Access Compliance Report

Public Rights-of-Way

(Curb Ramps)

Intersection ID: 13823	Main Street: HANOVER_ST	Cross Street: COMMONWEALTH_AV	Location: E
ADA ID: C606C1B3BBD6	Ramp Type: Perp	Initial Pass/Fail: Fail	Overall Compliance: No
Severity Score: 10			
Codes/Mitigation Info/Possible Solution		Field Measurements/Component Compliance

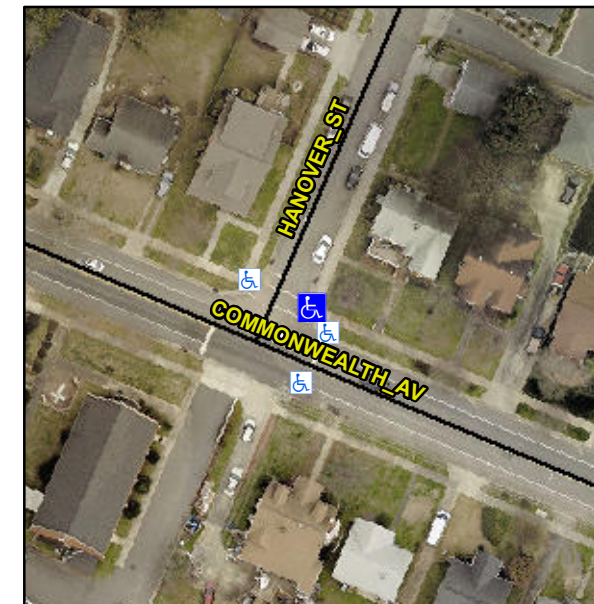
Not Found, R304.5.1, R304.5.3

Compliance	Description	Data	Compliance	Description	Data
N/A	Ramp Length (in)	72.0	Yes	Ramp Slope (%)	6.8
No	Ramp Width (in)	42.5	No	Ramp XSlope (%)	2.4
N/A	Flare Type LT	N/A	N/A	Flare Type RT	N/A
N/A	Flare Slope LT (%)	N/A	N/A	Flare Slope RT (%)	N/A
N/A	Flare Traversable LT?	N/A	N/A	Flare Traversable RT?	N/A
N/A	Landing Length (in)	N/A	N/A	DWS Provided?	N/A
N/A	Landing Width (in)	N/A	N/A	DWS Contrast?	N/A
N/A	Landing Slope (%)	N/A	N/A	DWS Length (in)	N/A
N/A	Landing X Slope (%)	N/A	N/A	DWS Full Width?	N/A
N/A	Landing Curb? (Y/N)	N/A	N/A	DWS Offset (in)	N/A
N/A	Shared Landing?	N/A			
N/A	Gutter Ponding?	N/A	N/A	Gutter Slope (%)	N/A
N/A	Gutter Lip Ht (in)	N/A	N/A	Gutter X Slope (%)	N/A
N/A	Painted X Walk1?	Yes	N/A	Painted X Walk2?	N/A
	X Walk 1 Direction	To NW		X Walk 2 Direction	N/A
N/A	X Walk 1 Width (in)	105.5	N/A	X Walk 2 Width (in)	N/A
	X Walk 1 Slope (%)	2.3		X Walk 2 Slope (%)	N/A
	X Walk 1 X Slope (%)	1.6		X Walk 2 X Slope (%)	N/A

Remove & Replace Entire Ramp.
